Curlew Street Streetscape Upgrade

Pre-Construction Detailed Design Road Safety Audit

Curlewis Street Streetscape Upgrade – Old South Head Road to Campbell Parade

Pre-Construction Detailed Design Road Safety Audit

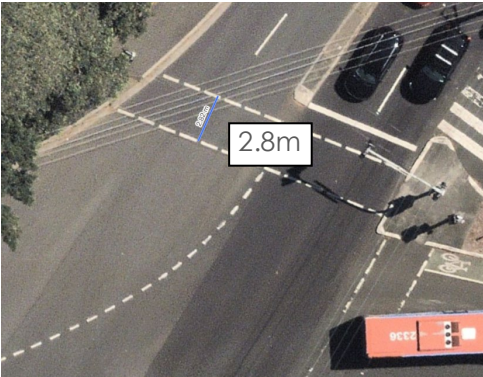
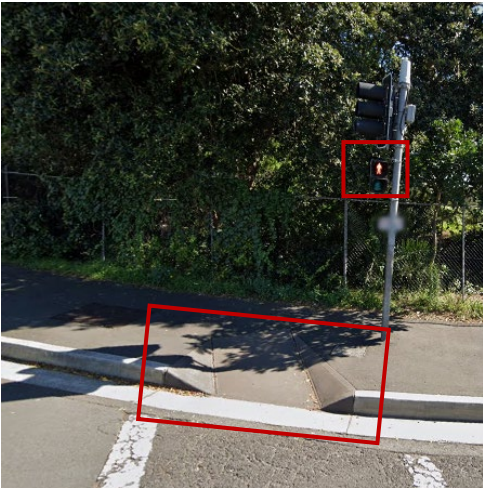
Item No.	Location	Descriptions of Findings	Design/ Photo	Likelihood	Severity	Risk Rating	Designer Response
1	West side of O'Sullivan Road	The cycleway design does not integrate with O'Sullivan Road in the northbound direction north of Old South Head Road. There is no shared use path on the west side of O'Sullivan Road north of Old Sullivan Road. Further, there is no bike ramp to enable a connection with O'Sullivan Road. This may result in cyclists continue cycling on the footpath, which would increase the likelihood of pedestrian/cyclist conflict. Alternatively, cyclists may rejoin O'Sullivan Road, however there is no delineation to inform northbound O'Sullivan Road motorists. It is noted that using a property driveway to connect with the roadway is considered unsafe due to the conflict with vehicles travelling into and out of the driveway.		Unlikely	Moderate	Medium	
2	Various locations in Curlewis Street	Confident cyclists cycling eastbound on Curlewis Street may avoid crossing points east of Old South Head Road, however they may want to connect with the shared path after the intersection. There is no provision of a bike ramp at the identified locations for on-road cyclists to access the shared path.				Note only

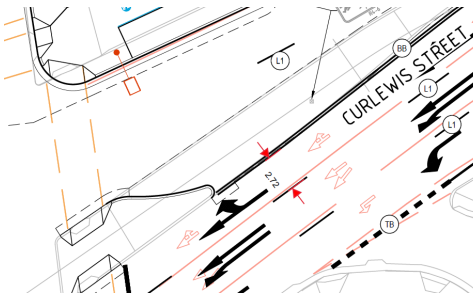
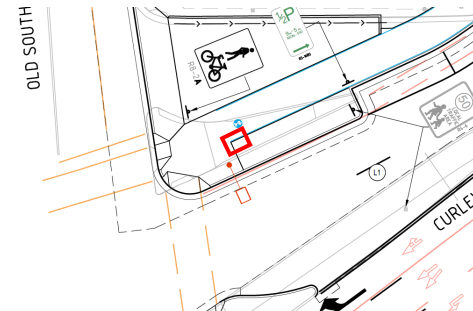
Item No.	Location	Descriptions of Findings	Design/ Photo	Likelihood	Severity	Risk Rating	Designer Response
3	Old South Head Road	The central median is about 2.2m wide but narrows at the tip, which is insufficient to fully accommodate more than one bicycle (or pedestrian with a pram) at a time waiting to across Old South Head Road (south leg). Cyclists may be caught in the central median towards the end of the walk clearance time. If the central median cannot contain the cyclist or pedestrian with a pram, this would expose them to passing traffic, and hence increase the risk of an incident.	  	Rare	Moderate	Low

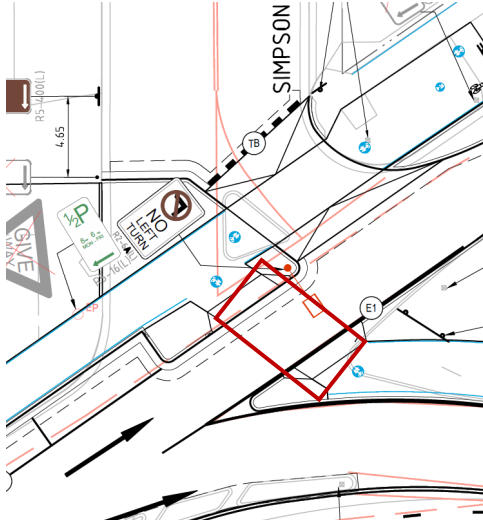
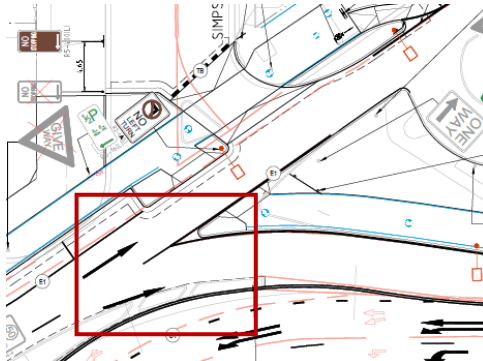
Item No.	Location	Descriptions of Findings	Design/ Photo	Likelihood	Severity	Risk Rating	Designer Response
4	Old South Head Road, Curlewis Street, O'Sullivan Road and Birriga Road intersection	The intersection of Old South Head Road, Curlewis Street, O'Sullivan Road and Birriga Road intersection is complicated as a five-way intersection. A near miss involving a right turning vehicle from Curlewis Street running into a vehicle from O'Sullivan Road was observed whilst on-site. Furthermore, it appears there are two departure lanes in Curlewis Street. In conjunction with the undefined lane discipline in O'Sullivan Road, this may result in vehicles travelling straight through the intersection from O'Sullivan Road towards the two departure lanes in Curlewis Street. This would make the filtered right turn movement more difficult to make against two lanes of through traffic, as opposed to one through lane under the existing condition. This may increase the likelihood of through/right collisions.	 	Unlikely	Minor	Low

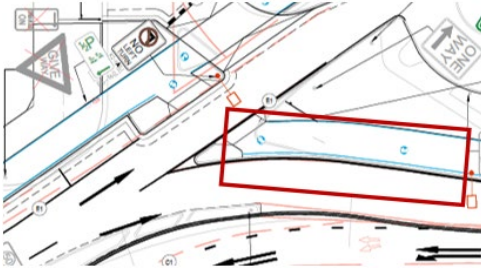
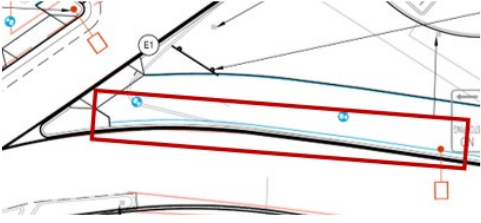
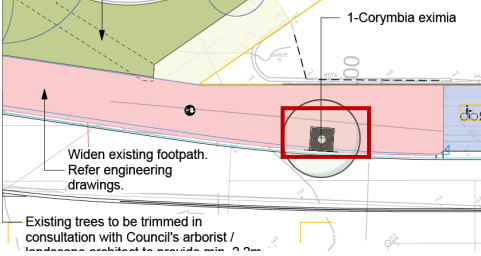
Item No.	Location	Descriptions of Findings	Design/ Photo	Likelihood	Severity	Risk Rating	Designer Response
5	O'Sullivan Road	There is no provision of a signalised pedestrian crossing in O'Sullivan Road to accommodate the pedestrian desire line in the north-south direction. This may result in pedestrians mixing with traffic when crossing the road, which may lead to vehicle-pedestrian collisions.		Unlikely	Moderate	Medium

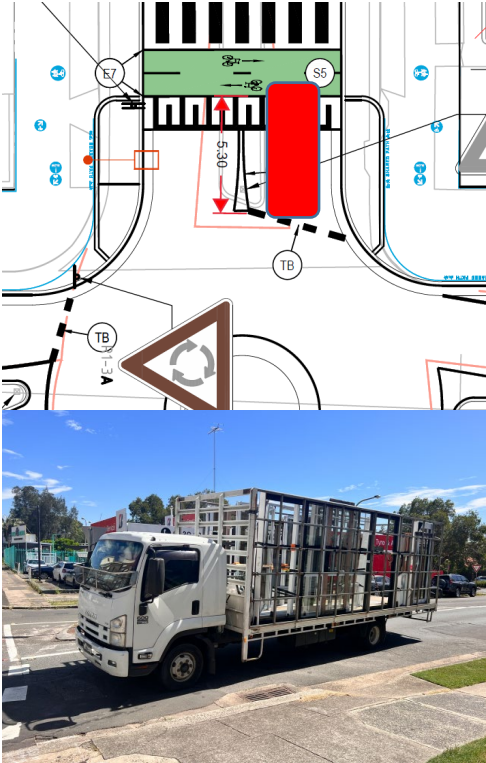
6	Old South Head Road, Curlew Street, O'Sullivan Road and Birriga Road intersection	The swept path assessment does not include the left turn movement from Old South Head Road to Curlew Street. It is not clear whether sufficient clearance is available to accommodate the left turn movement as a result of removing the left turn slip lane.		-	-	Note only

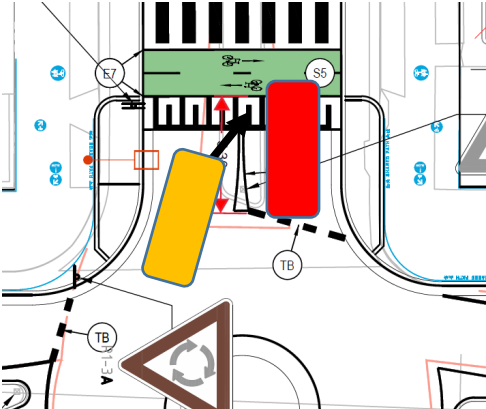
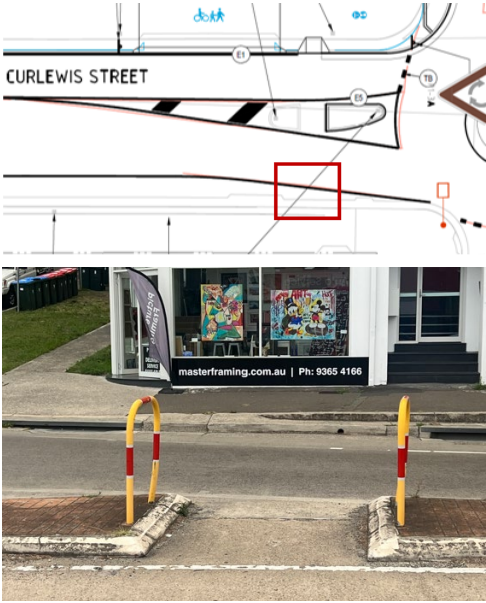
Item No.	Location	Descriptions of Findings	Design/ Photo	Likelihood	Severity	Risk Rating	Designer Response
7	Old South Road, Curlewis Street and O'Sullivan Road intersection	The design does not include an upgrade of the marked footpath crossing in Old South Road to enable a safe connection between the proposed shared use path on Curlewis Street and the existing one on O'Sullivan Road: - The existing marked footpath crossing is 2.8m wide, which is less than the minimum requirement of 3.6m based on the TfNSW Delineation Guide. - The existing kerb ramp at the north-western corner of the intersection is too narrow to accommodate both pedestrians and cyclists across Old South Head Road. Consequently, this may increase the likelihood of conflicts between cyclists and pedestrians using the crossing. Users may also travel outside the marked foot crossing which may lead to potential conflicts with passing vehicles.	 	Unlikely	Minor	Low

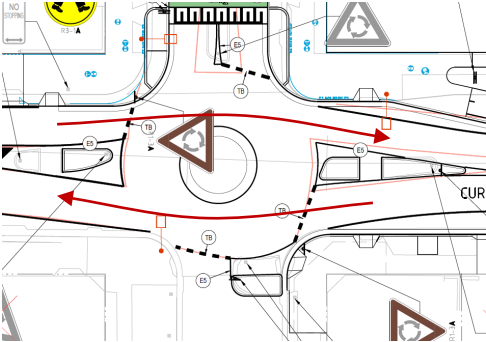
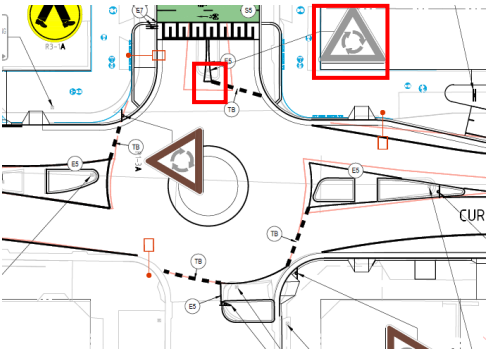
Item No.	Location	Descriptions of Findings	Design/ Photo	Likelihood	Severity	Risk Rating	Designer Response
8	Old South Road and Curlewis Street intersection	The shared through and right turn lane on Curlewis Street westbound is 2.7m wide, and may not be sufficient to accommodate the design vehicle along the curve towards the intersection, noting that the existing central median will be replaced by a double barrier line. Vehicles not staying within the lane may result in a side-swipe incident with vehicles in the adjacent lane.		Unlikely	Minor	Low	
9	Curlewis Street west of Old South Head Road	Utilities located within the future shared path area, if retained, will become hazardous to pedestrians and cyclists.	 	Unlikely	Minor	Low

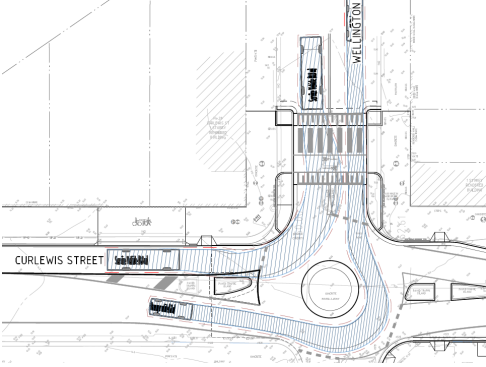
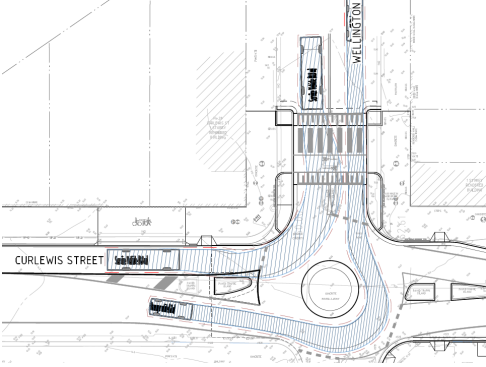
Item No.	Location	Descriptions of Findings	Design/ Photo	Likelihood	Severity	Risk Rating	Designer Response
10	Curlewis Street and Blair Street intersection	The design does not provide a crossing facility nor priority for shared path users at the crossing point in Blair Street. This crossing is located immediately following a diverge point. This may increase the risk of collisions with shared path users.		Unlikely	Minor	Low	
11	Diverge Point to Blair Street on Curlewis Street	Drivers may not be aware of the diverge point on Curlewis Street as a result of the following issues: - Pavement arrows give late notice of the split in traffic, road users not familiar with the area may make a late lane change to avoid taking the wrong turn. - The gore area is not well delineated with insufficient line marking and signage to emphasise its presence. Late lane change may cause turbulence in the traffic stream, which may increase the risk in side-swipe and rear-end collisions.		Unlikely	Moderate	Medium

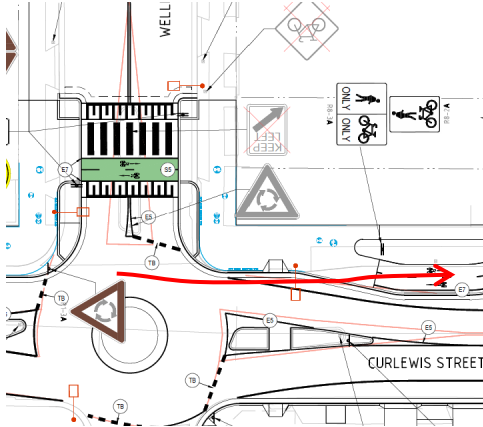
Item No.	Location	Descriptions of Findings	Design/ Photo	Likelihood	Severity	Risk Rating	Designer Response
12	Curlewis Street east of Blair Street	The proposed shared path is located directly behind the kerbline along the curve in Curlewis Street with no buffer / offset from passing traffic. There is a risk of errant vehicles traversing the shared path, which may result in conflicts with pedestrians and cyclists.		Unlikely	Moderate	Medium	
13	Curlewis Street east of Blair Street	There is no provision of physical separation from the travel lane along the outside of the curve. This would leave pedestrians and cyclists unprotected on the shared use path. This would increase the likelihood of conflicts between an errant vehicle and shared path users.		Rare	Moderate	Low	
14	Curlewis Street, east of Blair Street	The proposed new tree (Corymbia eximia) is located within the shared path which could obstruct visibility towards approaching shared path users. The tree and the pit would also reduce the effective width of the shared path and impede the travel path of a cyclist. This may increase the likelihood of cyclist-pedestrian conflicts.	 	Unlikely	Minor	Low

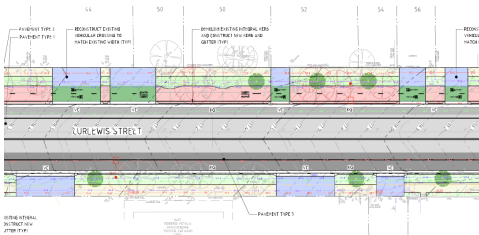
Item No.	Location	Descriptions of Findings	Design/ Photo	Likelihood	Severity	Risk Rating	Designer Response
15	Curlewis Street, between Blair Street and Wellington Street	The driveway treatment at two locations on Curlewis Street to the west of Wellington is inconsistent with driveway treatments painted green located to the east of Wellington Street. The shared path logo may not be prominent to motorists when accessing the driveway.					Note only

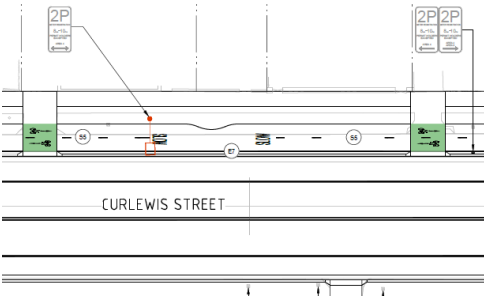
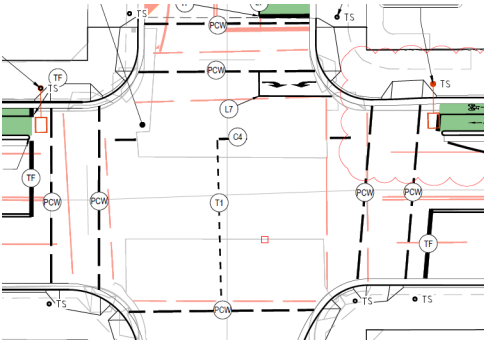
Item No.	Location	Descriptions of Findings	Design/ Photo	Likelihood	Severity	Risk Rating	Designer Response
16	Wellington Street – Pedestrian Crossing	There does not appear to be 6m between the give way line marking on the Wellington Street north approach and the cycleway crossing. Consequently, vehicles may encroach the cycleway crossing which may lead to conflict with cyclists. This safety concern is exacerbated when a large vehicle waits at the give way line.		Rare	Moderate	Low

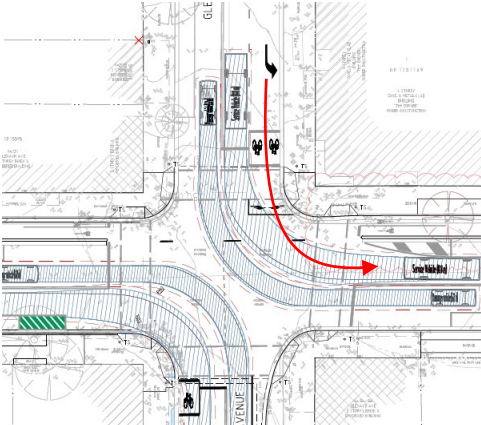
Item No.	Location	Descriptions of Findings	Design/ Photo	Likelihood	Severity	Risk Rating	Designer Response
17	Wellington Street – Pedestrian Crossing	Motorists waiting on the Wellington Street north approach to the roundabout may restrict the visibility of motorists traveling northbound on Wellington Street towards cyclists and pedestrians crossing Wellington Street. This would increase the likelihood of conflicts with cycleway and pedestrian crossing users at this location. If the pedestrian and cycle crossing is busy, the roundabout operation may become gridlocked which may lead to driver frustration and illogical driver behaviour.		Unlikely	Moderate	Medium

18.	Wellington Street, Curlewis Street roundabout	No kerb ramp has been provided on the south side of the west leg of the Wellington Street and Curlewis Street roundabout. Absence of the kerb ramp would not provide a smooth transition between the roadway and footpath for pedestrians with prams and in wheelchairs. They may walk in the roadway and cause conflicts with passing vehicles.		Rare	Moderate	Low

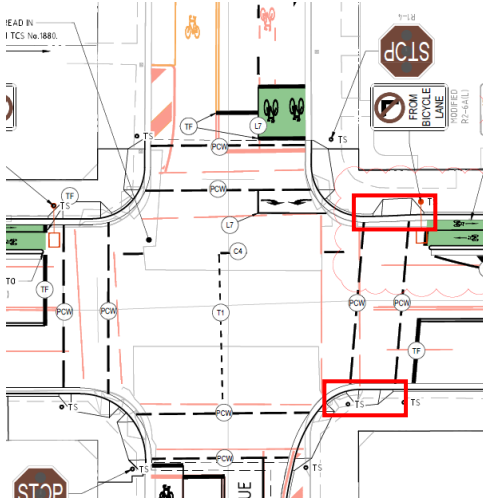
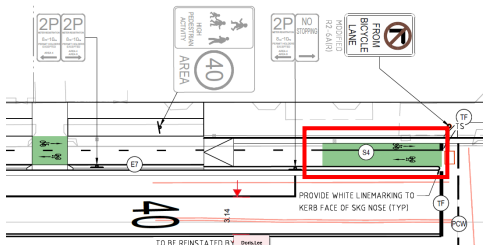
Item No.	Location	Descriptions of Findings	Design/ Photo	Likelihood	Severity	Risk Rating	Designer Response
19	Wellington Street, Curlewis Street roundabout	Kerb build-outs on both Curlewis Street approaches to Wellington Street provide little deflection for motorists heading westbound and eastbound on Curlewis Street. Vehicle speeds may remain high when travelling through the roundabout, and increase the likelihood of collisions with other road users.		Rare	Moderate	Low	
20	Wellington Street, Curlewis Street roundabout	An existing 'Roundabout Give Way' sign would be located within a small painted median island on the north leg of the roundabout. The signpost could be knocked down by turning vehicles in the absence of a raised median island, as shown in the swept path diagram. This could cause damage to other vehicles. Subsequently, this could also result in vehicles not noticing the signage and stopping after the give way line marking which could result in an incident.		Unlikely	Moderate	Medium

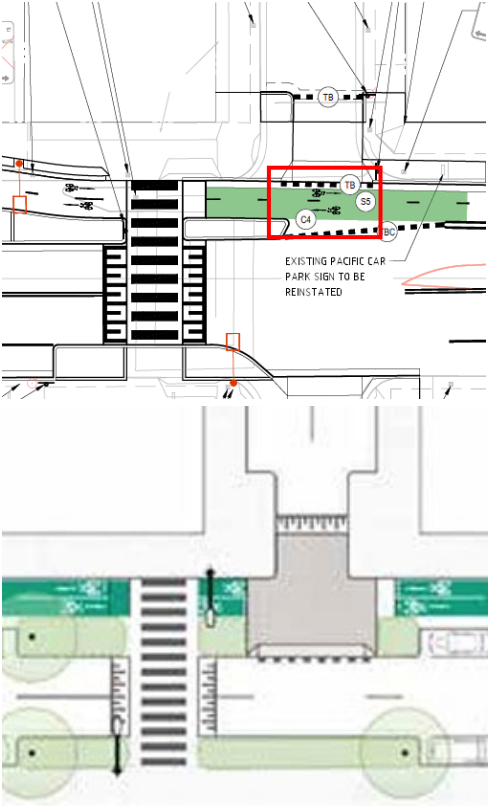
Item No.	Location	Descriptions of Findings	Design/ Photo	Likelihood	Severity	Risk Rating	Designer Response
21	Wellington Street, Curlewis Street roundabout	The swept path of the Curlewis Street to Wellington Street left turn movement encroaches the centreline and painted island in Wellington Street, which would be impeded by a southbound vehicle if it sits in the middle of the travel lane, as opposed to the swept path diagram that shows the southbound vehicle hugging the kerbline. As a result, this may increase the likelihood of side-swipe conflicts.	 	Unlikely	Moderate	Medium

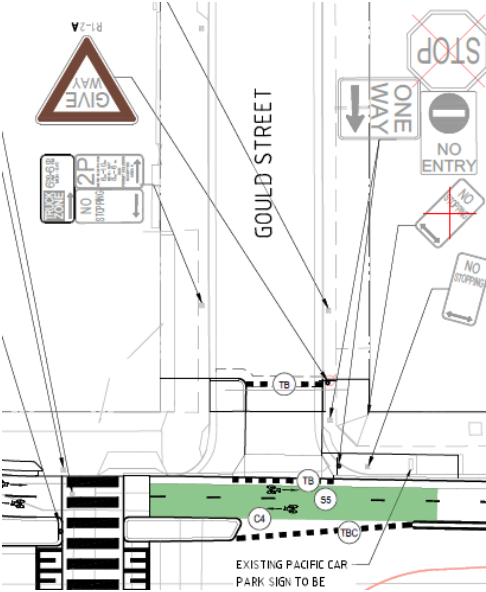
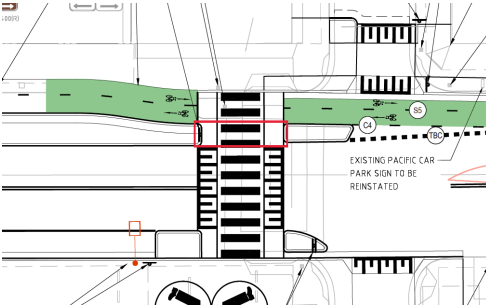
Item No.	Location	Descriptions of Findings	Design/ Photo	Likelihood	Severity	Risk Rating	Designer Response
22	Wellington Street, Curlewis Street roundabout	Confident cyclists cycling eastbound on Curlewis Street may avoid the shared path facility west of Wellington Street, however they may want to connect with the cycleway when it transitions to a bi-directional cycleway. There is a lack of a bike ramp to enable the connection to the cycleway.		-	-	Note only	
23	Wellington Street, Curlewis Street roundabout	The design plan does not indicate whether the existing Raised Retro-Reflective Pavement Markers (RRPM) would be replaced to delineate the shifted centreline in Curlewis Street, on approach to the Wellington Street roundabout.				Note only

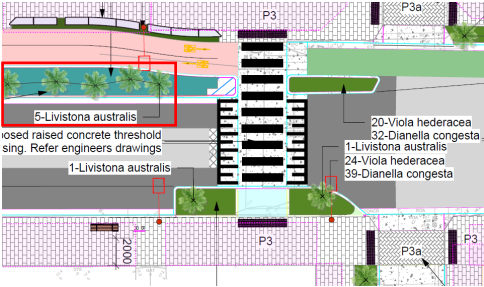
Item No.	Location	Descriptions of Findings	Design/ Photo	Likelihood	Severity	Risk Rating	Designer Response
24	General finding	There are several driveways along the route where motorists will be required to reverse across the proposed cycleway as there is insufficient area on-site to enter and exit in a forward direction. Inter-visibility between a cyclist and a driver turning into the driveway from Curlewis Street may be obstructed by vehicles parked in the parking lane. A motorist may not have full visibility of oncoming cyclists when reversing which may lead to them reversing into cyclists. Furthermore, vehicles awaiting a gap in traffic at a driveway may impede both directions of the cycleway. Likewise, vehicles entering a driveway from Curlewis Street may also impede the cycleway when they yield to pedestrians in the footpath. There is a potential risk to cyclists if motorists failed to cross the cycleway at an appropriate and safe time.		Unlikely	Moderate	Medium

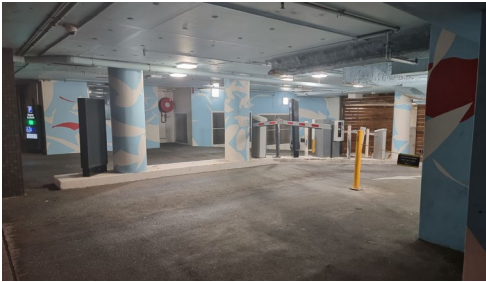
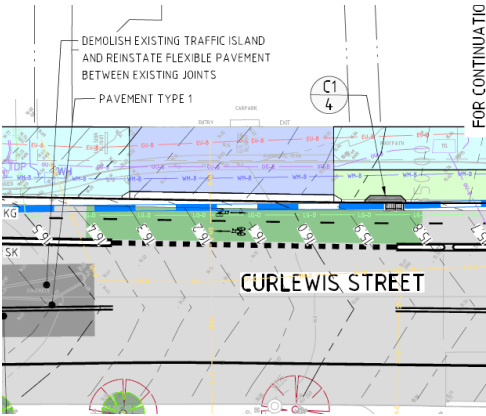
Item No.	Location	Descriptions of Findings	Design/ Photo	Likelihood	Severity	Risk Rating	Designer Response
25	General finding	It was observed on many occasions that delivery vehicles double park within the travel lane when kerbside parking is not available. Under the existing condition, vehicles would overtake the stationary vehicle by partially encroaching into the travel lane in the opposite direction, in the absence of a centreline. The proposed scheme would narrow the travel lanes with provision of a double barrier centreline. Motorists are not legally allowed to encroach the centreline to overtake the stationary delivery vehicles. However, it is likely that some motorists may breach the road rule by crossing over the double barrier line. This would increase the likelihood of a side-swipe collision due to the reduced buffer in the narrowed travel lanes.	 	Unlikely	Moderate	Medium	
26	Glenayr Avenue and Curlewis Street intersection	The hook turn bay is 4 to 5.2m long to accommodate eastbound cyclists waiting to turn right, and westbound cyclists waiting to turn left towards Glenayr Avenue southbound. Considering Austroads require 3m for the hook turn bay (one direction), the proposed bay is too short to accommodate two bicycles in opposite directions. This may result in conflicts between cyclists, or cyclists storing outside the hook turn bay. Furthermore, the hook turn bay has no bicycle line marking (i.e. green paint and		Unlikely	Minor	Low

Item No.	Location	Descriptions of Findings	Design/ Photo	Likelihood	Severity	Risk Rating	Designer Response
		bike symbol) and therefore may not be used correctly. Cyclists may ignore this and will use a conventional right-turn which has a greater risk of collision with vehicles. Of note, hook turns can be used as an alternative to a conventional right-turn from the centre of the road under the <i>Australian Road Rules (National Transport Commission 2012)</i>, however, there is no mention of left turn hook turns within the Austroads Guide. Lastly, consideration should be given to providing a hook turn for the Glenayr Avenue to Curlewis Street right turn movement.					
27	Glenayr Avenue and Curlewis Street intersection	The swept path assessment shows the left turn movement being made from the second lane (median lane) on Glenayr Avenue onto Curlewis Street rather than straddling both lanes. Consequently, motorists turning left from the kerbside lane may conflict with motorists turning left from the median lane.		Unlikely	Moderate	Medium

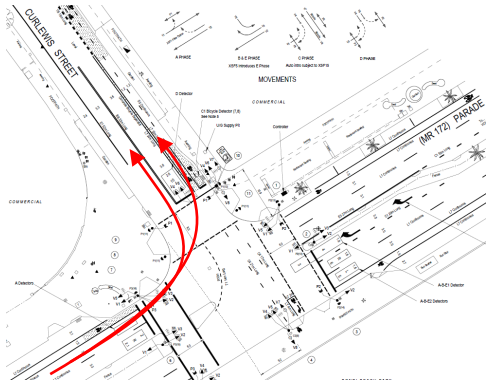
Item No.	Location	Descriptions of Findings	Design/ Photo	Likelihood	Severity	Risk Rating	Designer Response
28	Curlewis Street, east leg at the Glenayr Avenue intersection	The proposed kerb ramps are 2.3m wide in Curlewis Street and do not extend the full width of the marked foot crossings which are about 3.6m wide on Curlewis Street. RMS Guide to Traffic Signals Appendix D suggests kerb ramps should ideally be the full width of the crossing.				Note only	
29	Curlewis Street, west leg at the Glenayr Avenue intersection	The width of the eastbound cycleway appears too narrow and is inconsistent with the width of the upstream cycleway. It could be a CAD error.				Note only

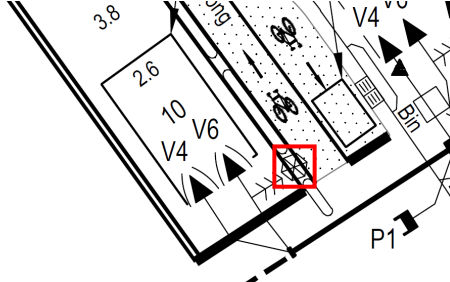
Item No.	Location	Descriptions of Findings	Design/ Photo	Likelihood	Severity	Risk Rating	Designer Response
30	Gould Street – north approach	The cycleway is not included in the raised continuous footpath treatment. An example design stipulated in TfNSW cycleway Toolbox involves an extension of the raised platform past the intersection.		Rare	Moderate	Low

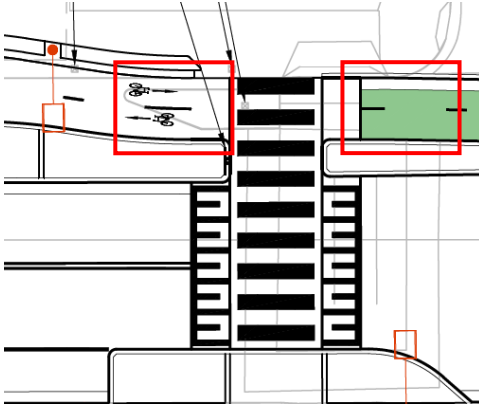
Item No.	Location	Descriptions of Findings	Design/ Photo	Likelihood	Severity	Risk Rating	Designer Response
31	Gould Street – north approach	No advance cycle crossing ahead signage is provided on the Gould Street north approach to Curlewis Street. Drivers may not be aware of the cycle crossing after the raised pedestrian facility and could collide with passing cyclists.		Rare	Moderate	Low	
32	Pedestrian crossing on Curlewis Street west of Gould Street	The storage area for pedestrians travelling south on the pedestrian crossing between the cycleway and road is small. Pedestrians may store outside the storage area which may result in conflicts with cyclists or passing vehicles. Further, given this area is a decision point for pedestrians, it should not be marked as a pedestrian crossing, as it would give pedestrians a false impression that the crossing is continuous without having to look out for traffic after crossing the cycleway or the roadway.		Rare	Moderate	Low
